Department of Planning and Zoning

MEMORANDUM

To: The Design Advisory Board
From: Mary O'Neil, AICP, Senior Planner
RE: ZP 14-0499CA/MA; 237 North Winooski Avenue
Date: November 26, 2013

File: ZP 14-0499CA/MA
Location: 237 North Winooski Avenue
Zone: NMU Ward: 2
Date application accepted: October 23, 2013
Applicant/ Owner: Hot Eats, Cool Treats LLC (Redstone) / Kathy Goguen
Estimated Construction Cost: \$3,000,000
Request: Demolish former Dairy Queen / currently "Q-Tee-s" restaurant, redevelop site with a single building of 28 residential units and approx. 1,500 sf commercial space. Parking is proposed to be on grade located under the building in an open garage.

EXISTING CONDITIONS SITE PLAN

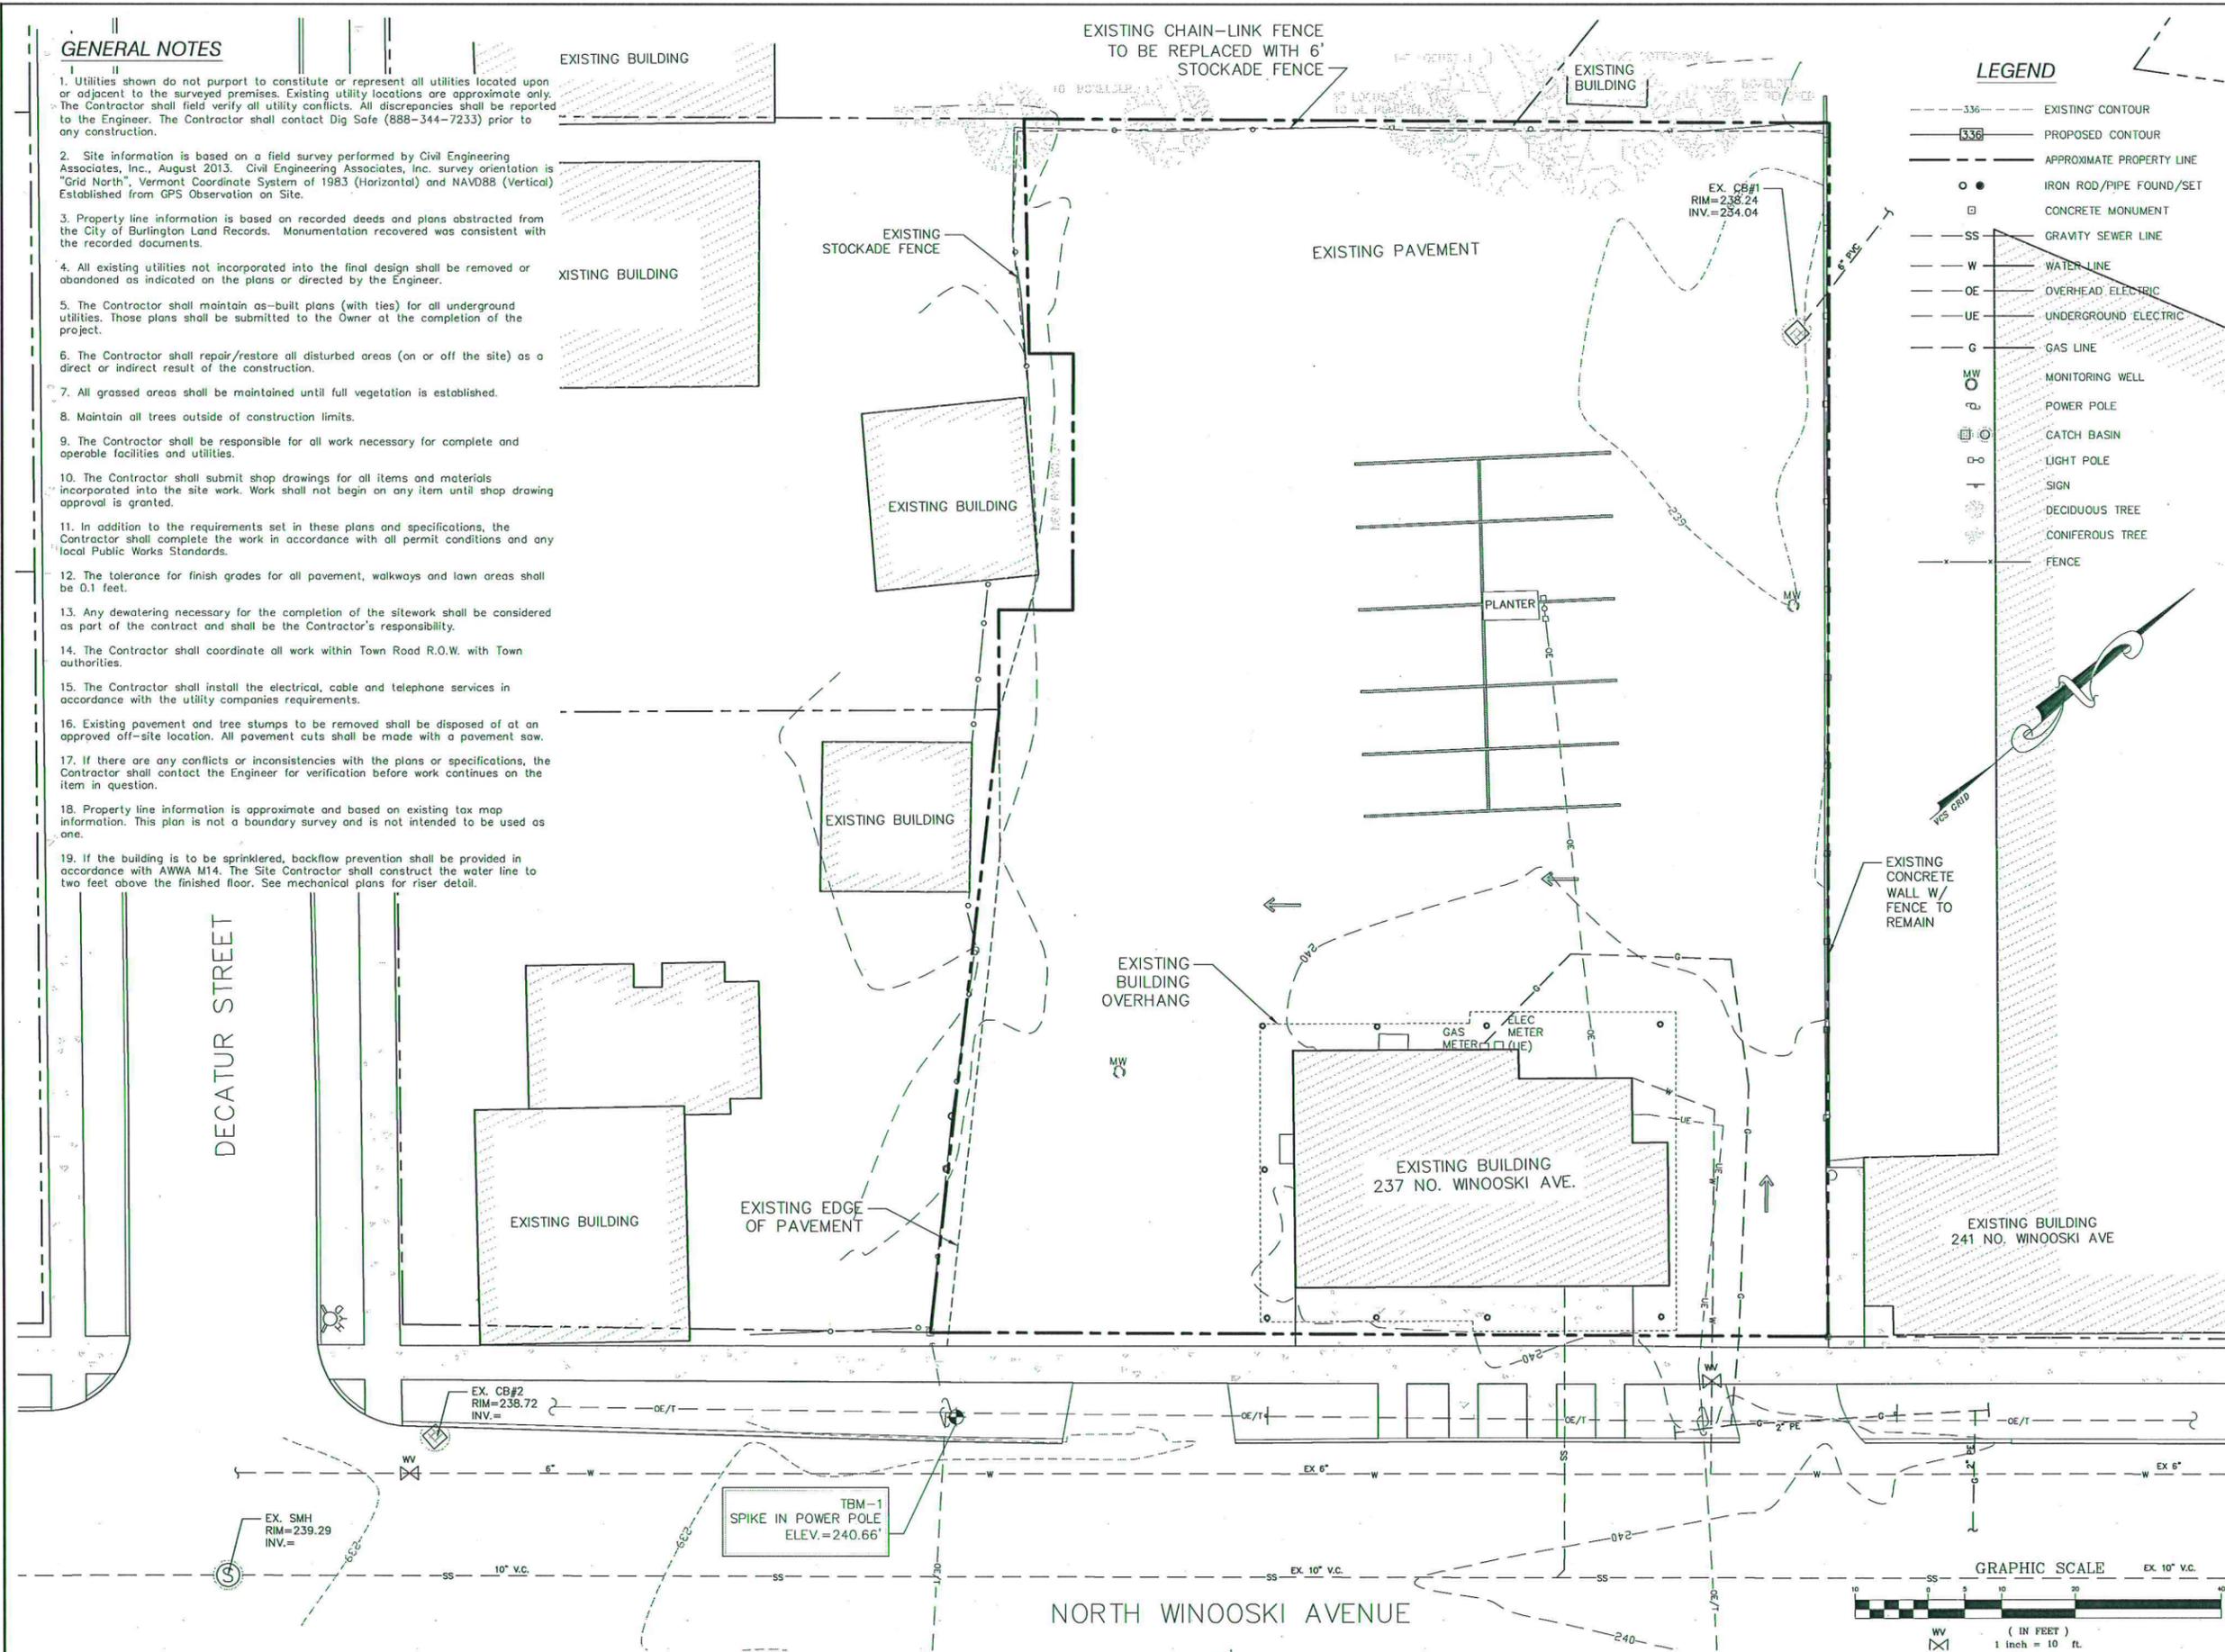
Plan C1.0, Existing conditions, identifies the presence of Monitoring Wells. Phase I and II site assessments have been completed for this property. The applicant will be required to demonstrate compliance with any site treatment or mitigation as determined by the State of Vermont Department of Environmental Conservation (DEC.) Any modified site or other design plans resulting from the mitigation will need to be considered in the project review.
